UN Regulations Nos. 13 & 13-H Electrical Brake System Drafting Guidance

Figure 2. Electric braking system with internal combustion engine

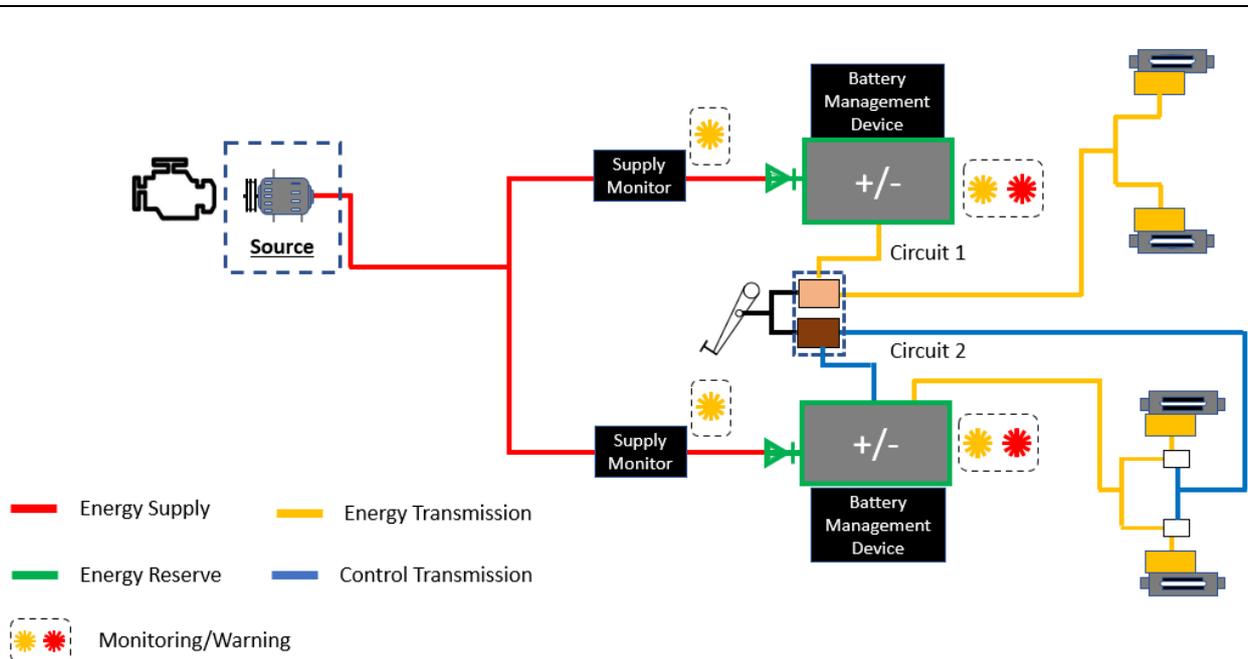
The CLEPA proposal provides for the energy to be based on the value of both Watts and Joules. These values are to be monitored and warnings provided if the values drop to a level at which the brake system performance is compromised.

In addition, the proposal includes a requirement to warn the driver if the value from the supply system is insufficient to maintain the values in the energy storage devices (e.g., batteries).

It has to be established how the actual values will be set and how they will be measured and monitored.

It has to be established how this value will be set and how it is measured and monitored.

It is necessary to be explicit regarding what is expected by a "full brake application" as this will necessarily be different to the understanding when assessing pneumatic systems.

This a matter of dimensioning and the provision of circuit protection devices. The regulatory provisions must be such that this can be tested as part of type-approval (Annex 4).

Figure 4. System concept for passenger car and light commercial vehicles.

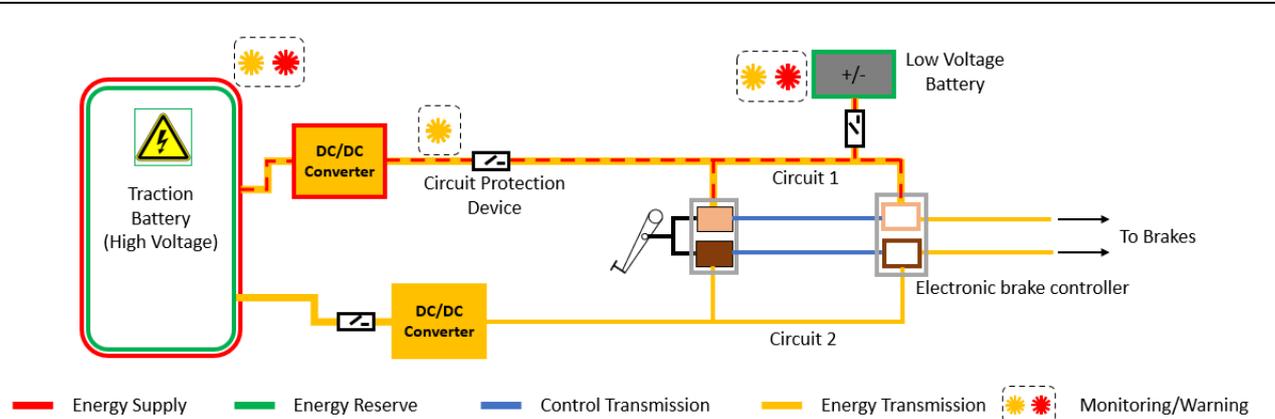
The energy transmission of both circuit 1 and 2 use a single energy reserve (contained within the traction battery) this seems contrary to the regulation. However, circuit 1 has an independent energy reserve that can provide energy to the transmission should a fault occur in the supply from the traction battery.

Challenge 1 – if the supply to circuit 1 was interrupted by a DC/DC failure, the low voltage battery (top right) would supply the energy transmission of circuit 1. Both circuit 1 and 2 would continue to operate.

Challenge 2 – A failure of the traction battery would result in the loss of energy to circuits 1 and 2, but the low voltage battery in circuit 1 (and protected) would be available to ensure secondary braking.

Challenge 3 – An electrical failure in any part of the supply or transmission risks damaging both circuit 1 and 2. Protection devices are present downstream of the DC/DC converter of circuit 1 and in the feed/supply to the low voltage battery. In circuit 2 the protection device is located upstream of the DC/DC converter. These protection devices would need to meet regulatory criteria to ensure effectiveness.

This requires more study, the introduction of specific performance-based requirements, and validation procedures.

Nevertheless, it seems that the arrangement could meet the principle of having two independent braking circuits. Special consideration must be given to “redundancy” – this term is used often but can have different meanings.

There are two separate energy reserves but are they truly independent? The low voltage reserve is reliant on the supply function of the traction battery and in normal operation both circuits 1 and 2 will use energy from the traction battery for their operation. However, the low voltage battery is available and, under conditions where the traction battery is compromised and unable to supply energy to the energy transmission of circuit 1, the circuit will be provided with energy from the low voltage battery.

This requires more study, but it seems that the intention of the regulation is met by this new arrangement, however a regulatory provision would need to be drafted to provide surety.

Here, the requirement for monitoring of the reserves of each circuit (Watts and Joules), and the provision for driver warning signals, remains. Consideration has to be given regarding how that requirement is worded today and whether additional text is required for this particular arrangement.

It is understood that the neither the high voltage (traction) or the low voltage battery will have physical separation of the energy reserve available to the braking system. This may affect how the monitoring and warnings are provided. See the next section.

The use of the traction battery for both the energy supply and the energy transmission raises a concern given the high demand on that battery from the traction motors. It will be necessary to ensure that the traction battery can guarantee the necessary availability of energy for the energy supply and the energy transmission at all times – even when the supply for the traction motor(s) has been fully consumed.

This will require provisions to be drafted in the regulations, including a validation procedure. Subject to those provisions it seems the intention of Principle 4 can be met.

Provisions need including in Annex 7 so that the traction battery (and the low voltage battery) are dimensioned in such a way that the guaranteed energy reserve for the braking system is sufficient for this requirement. The provision would need to provide for the traction battery to be conditioned such that, during the assessment, the brake transmission receives only the energy that is guaranteed to be available.

Figure 5. Natural partitioning of a battery.

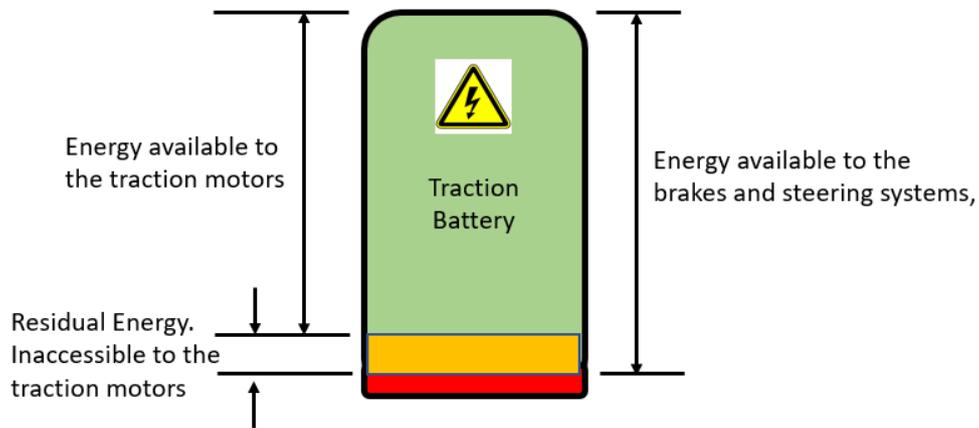
Can this residual energy be considered to be an independent reserve for the purposes of a single braking circuit?

Can the value of the residual energy reserve be guaranteed?

Is this the point at which the independence of the two circuits, one powered by the low voltage battery and the other by the residual energy of the traction battery, has to be ensured?

Can the performance requirements of Annex 7 (R13), in respect to brake performance with the supply is stopped, be fulfilled when there is only residual energy available?

Can the battery be suitably conditioned to allow for the assessment of it as an energy reserve for the braking (and steering?) system?
